March 19, 2019

Project No. 12091-01

**Subject:** *Preliminary Geotechnical Evaluation and Response to City Review Comments for Proposed San Pedro Distribution Center, 1599 W. John S. Gibson Boulevard, Los Angeles, California*

## **5.0 RESPONSE TO CITY REVIEW COMMENTS**

# **Geotechnical Map**

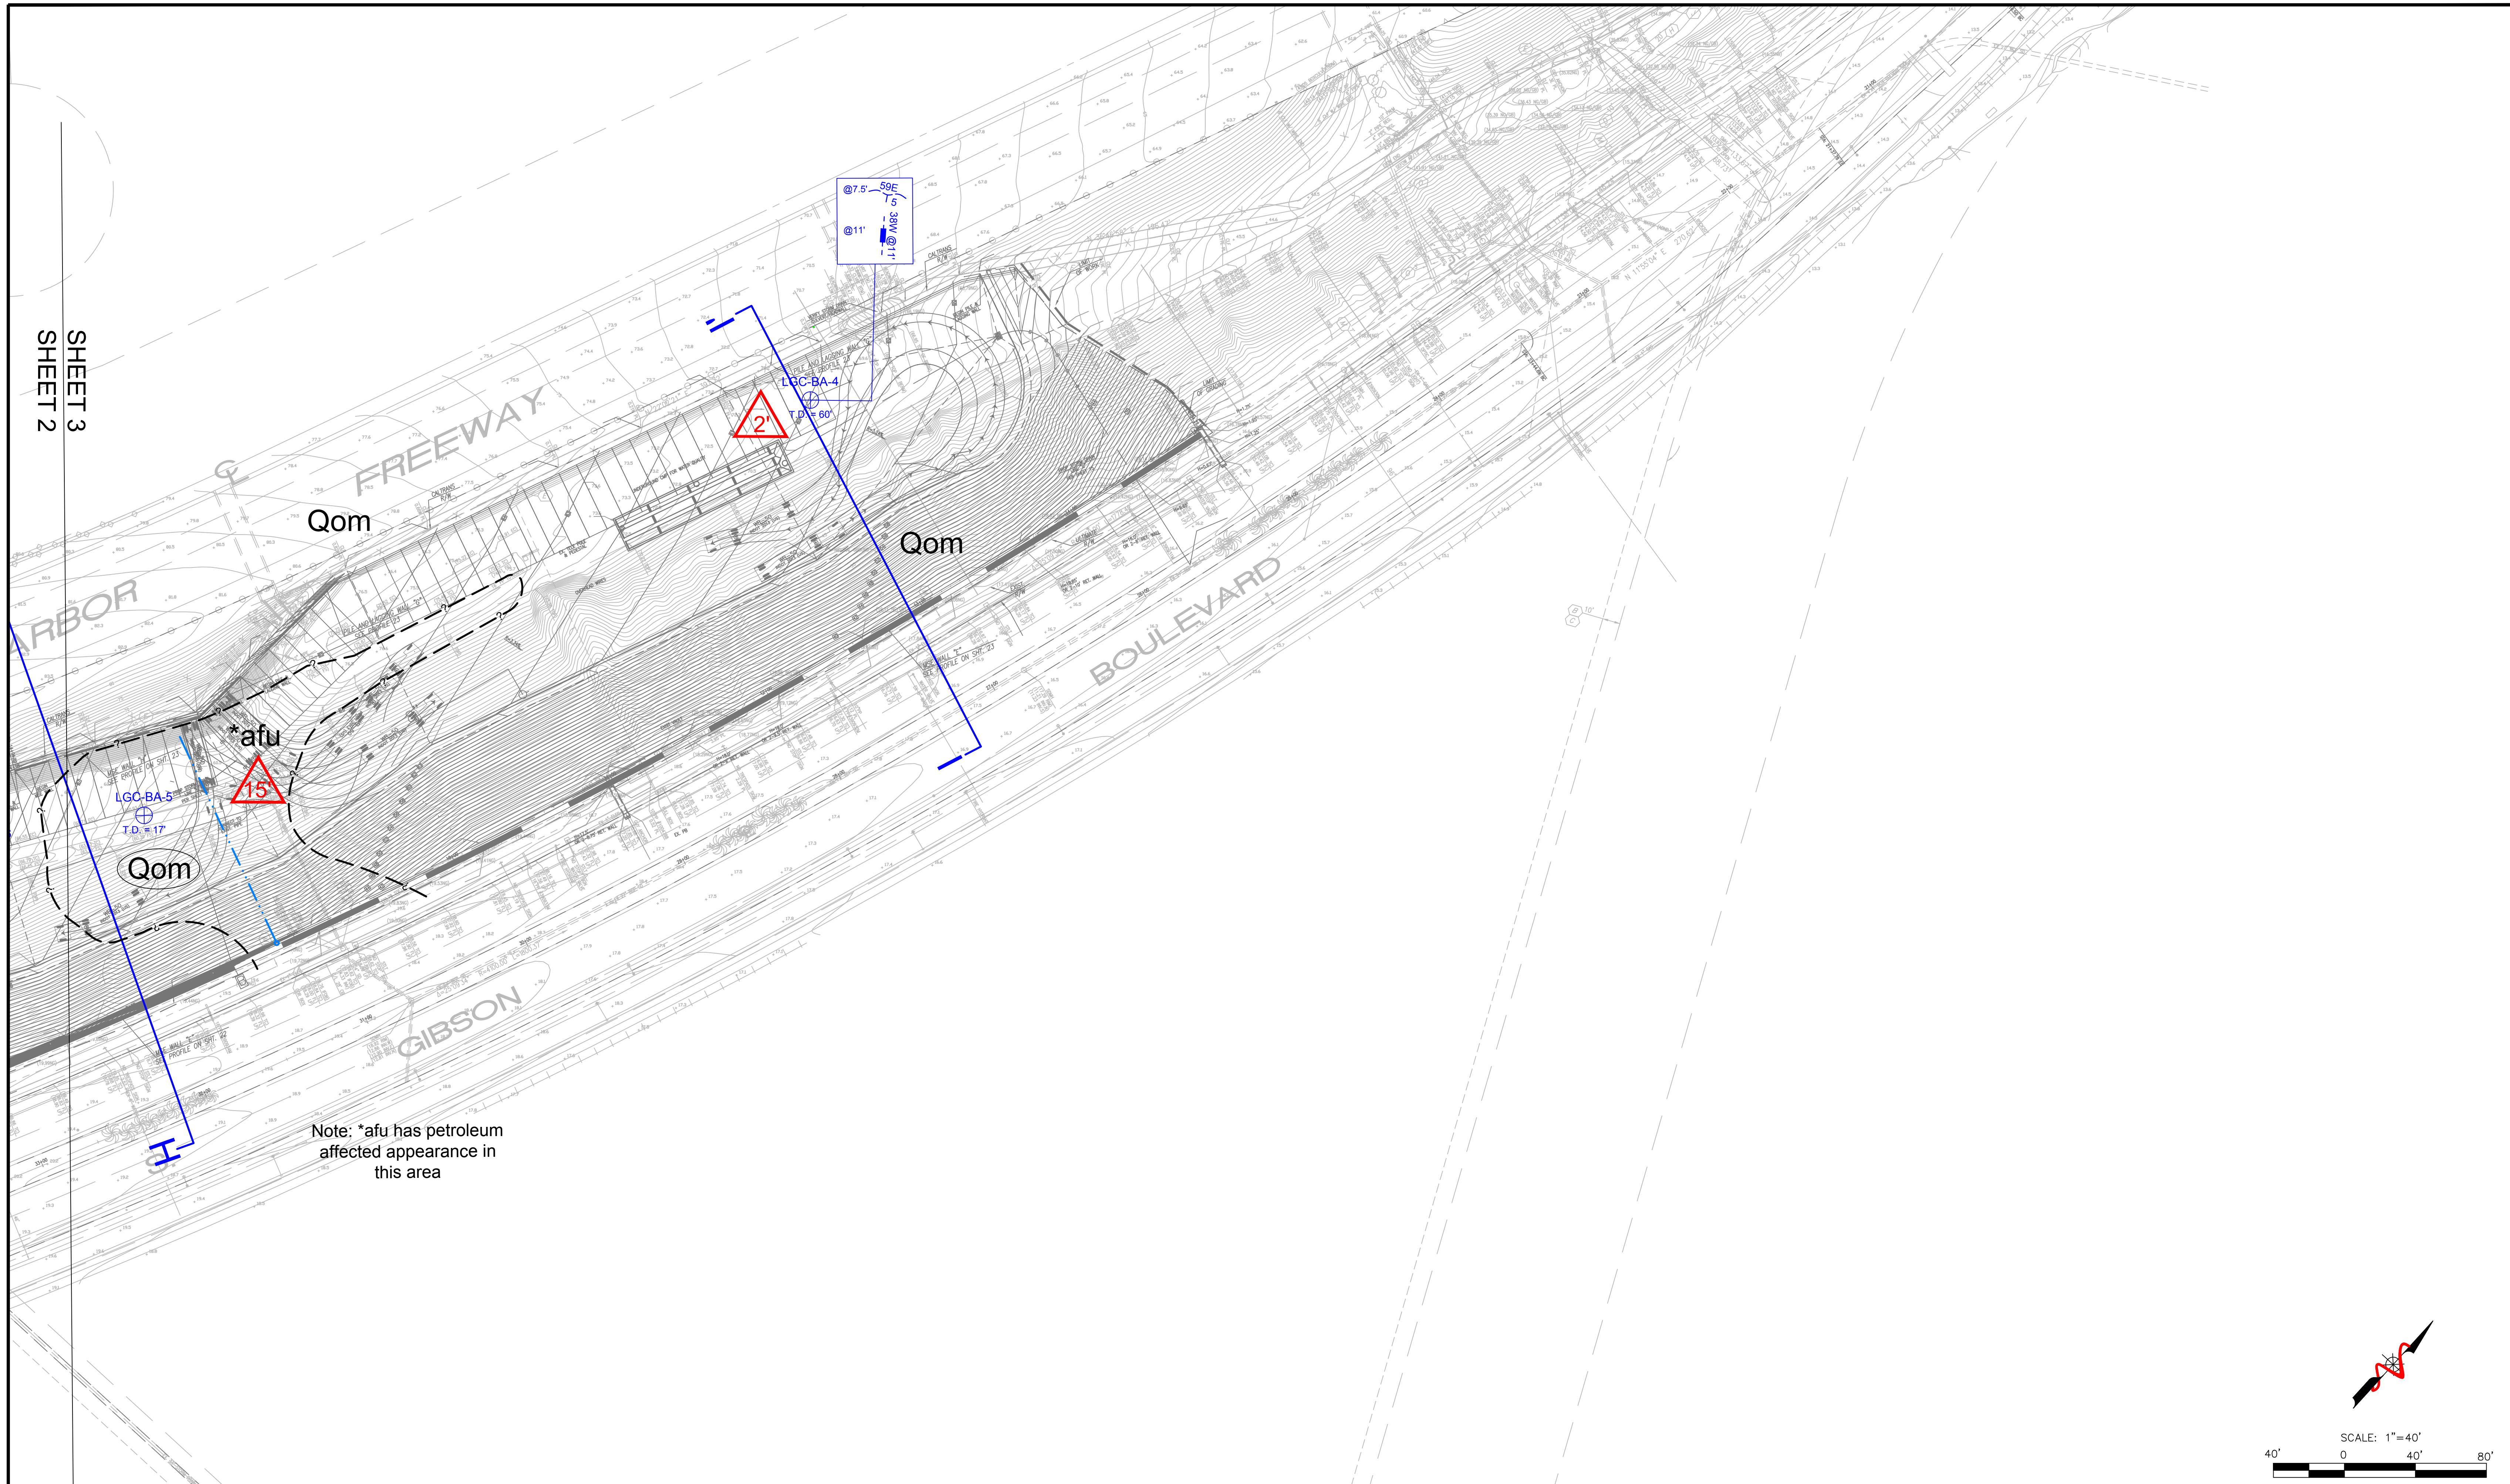
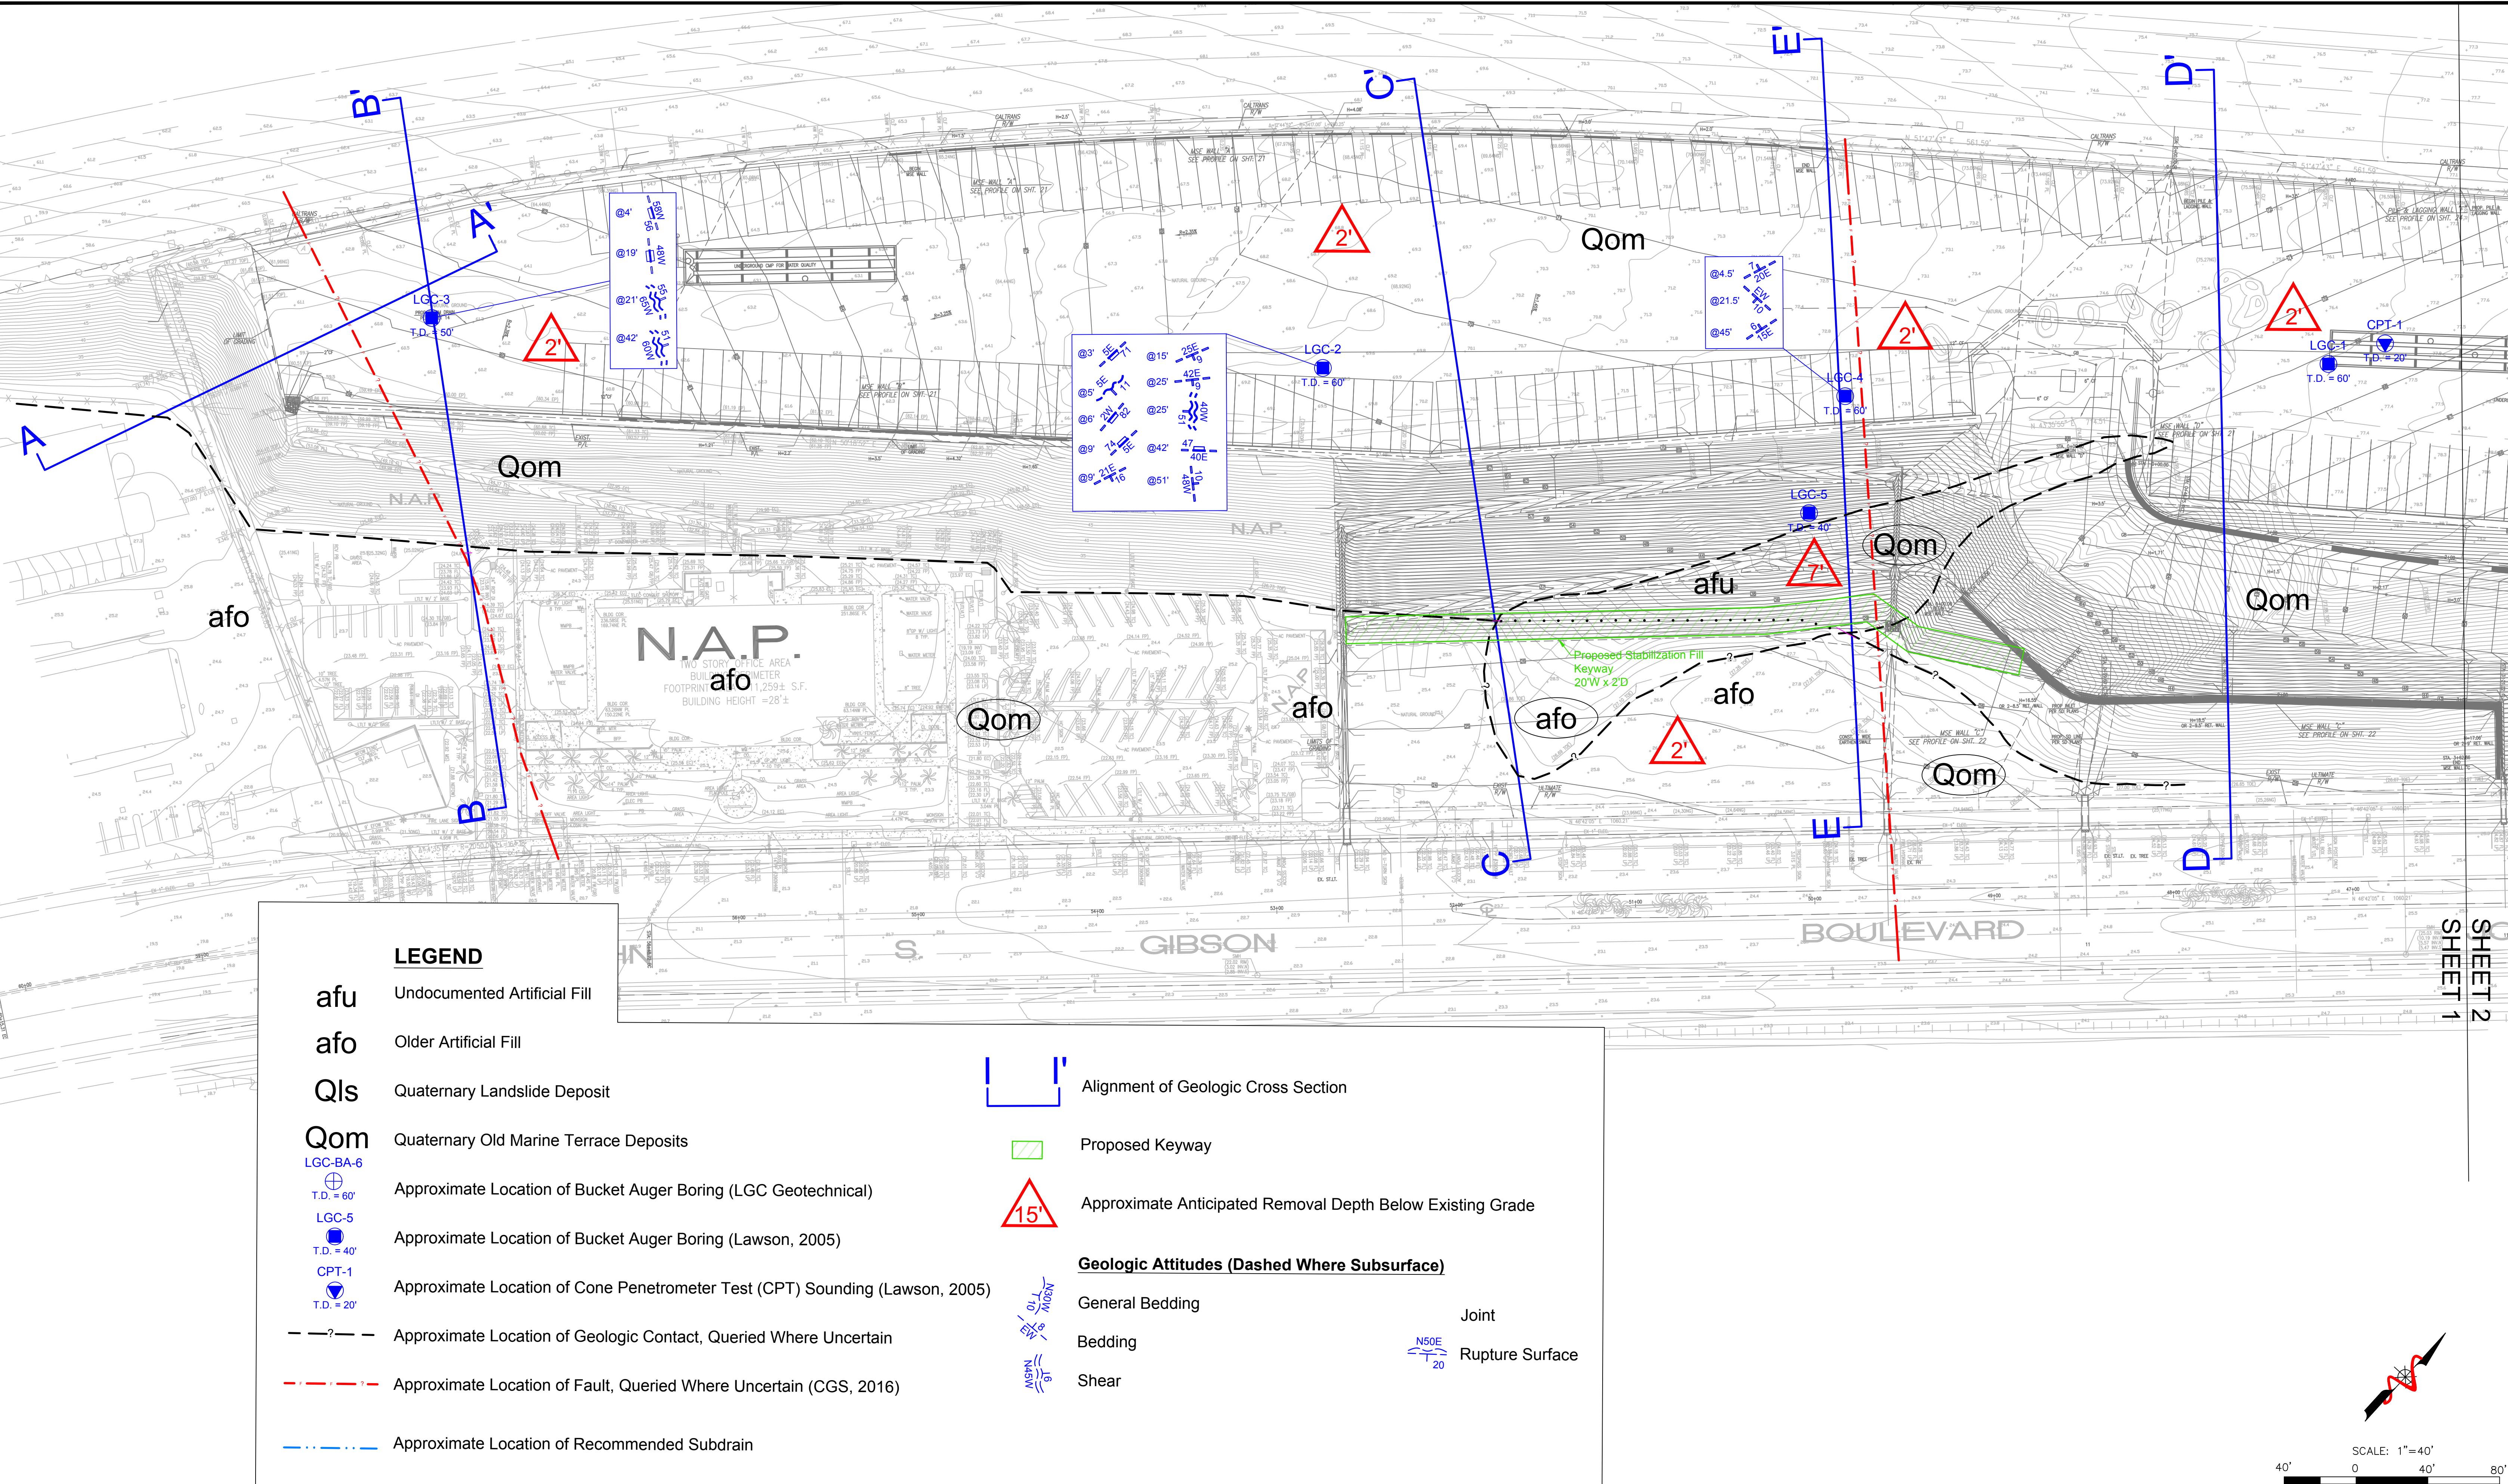
“No map was provided with the current update report reflecting the proposed site conditions. Provide recommendations and revise the plan(s) and cross sections(s) for providing the required building setback from the toe of the ascending slope as specified by Code Section 1808.7.1.”

"Provide a geologic map and cross sections that are based upon conceptual grading or site development plans, to illustrate all proposed and existing contours relative to the planned grading and/or construction, along with all off-site slopes and conditions that could adversely affect the stability or safety of the site (7006.3.2). The geologic map and cross sections shall depict the top and bottom of slopes; lithologic contacts; bedding attitudes; locations of slumps, landslides, or faults relative to the subject site; existing and proposed topographic profiles; existing and proposed structures; and, required Code setbacks. (7006.3.2)"

Refer to the attached Geotechnical Map (Sheets 1 through 3). No building structures are planned for the site.

Refer to the attached Geotechnical Map and Geotechnical Cross Sections (Sheets 1 through 5). No building structures are planned for the site.
